TORRANCE TRANSIT REGIONAL PARK & RIDE TERMINAL

DESIGN GUIDELINES & STANDARDS

OCTOBER 10, 2012

The Torrance Transit Park & Ride Regional Terminal Guidelines and Standards report documents the results of the 3 week design review process involving City staff and the RNL team. This report is organized by topic, beginning with building architecture, then canopy, and finally site development. During this process, the project design was developed considerably further than the existing 30% design, which will necessarily require modification to the existing 30% package. However, to reiterate,

Figure 4.1 30% design proposed canopy locations

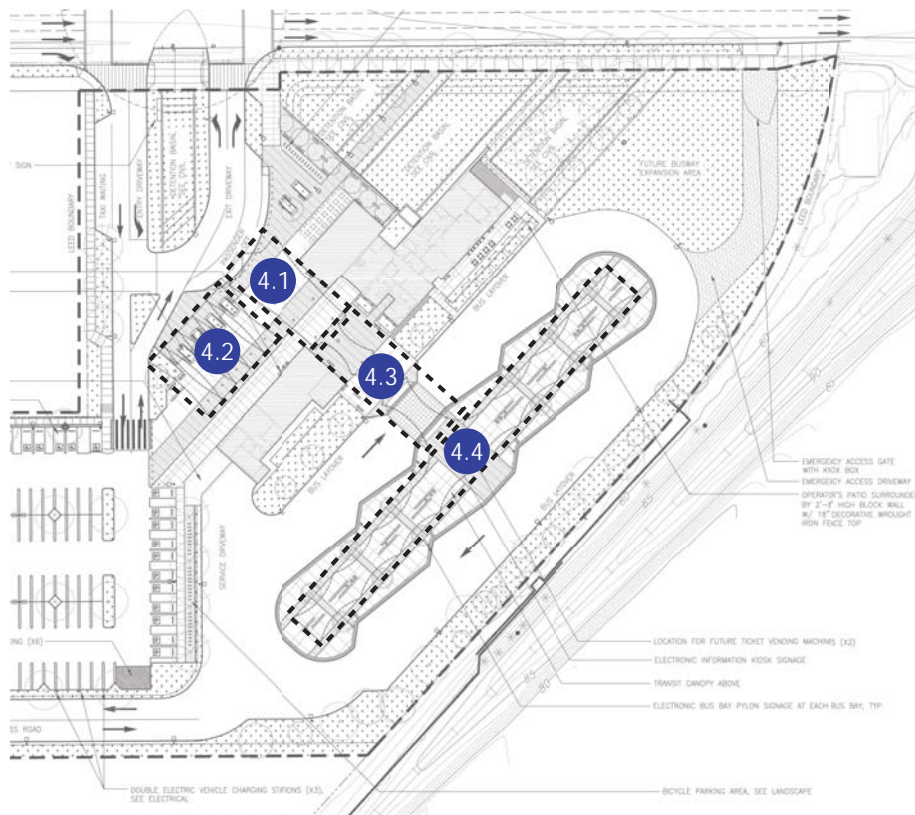
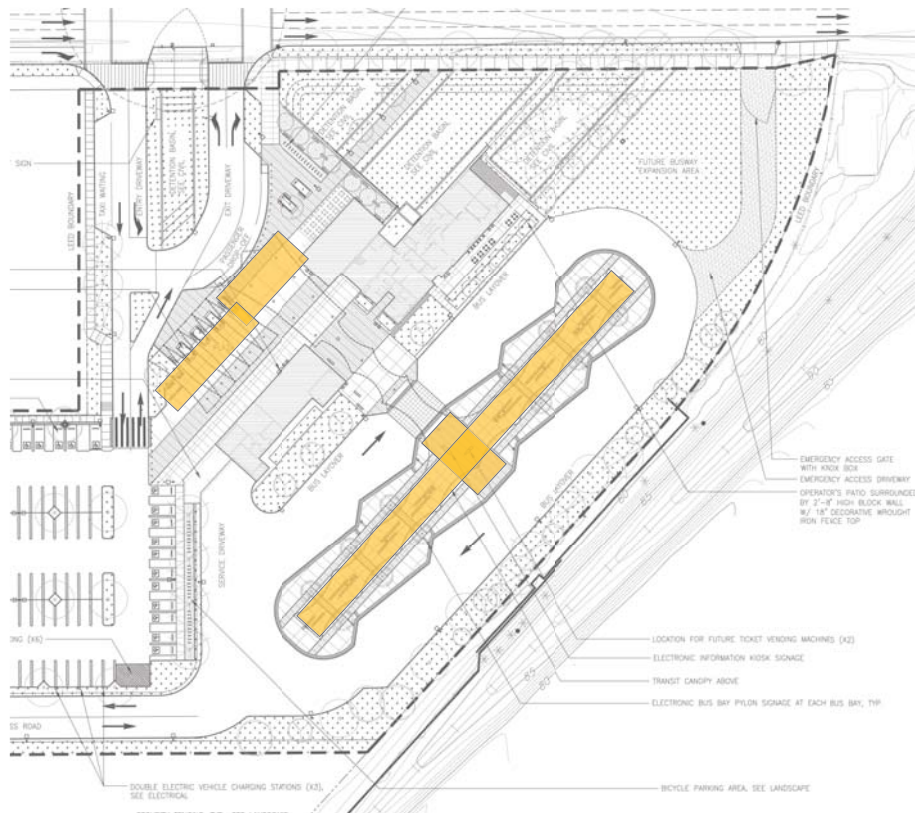
In conclusion, it was resolved that the amount of outdoor cover on the project at the conclusion of 30% Design was excessive. Reduction of unnecessary canopy cover will result in a more simplistic and aesthetically pleasing environment containing a more functional plaza with an overall reduced cost to the Project. Through further design, the "twisted ribbon" canopy theme, based on the Bard College canopy, could provide the "wow factor" desired by the City. (Figure 4.5).
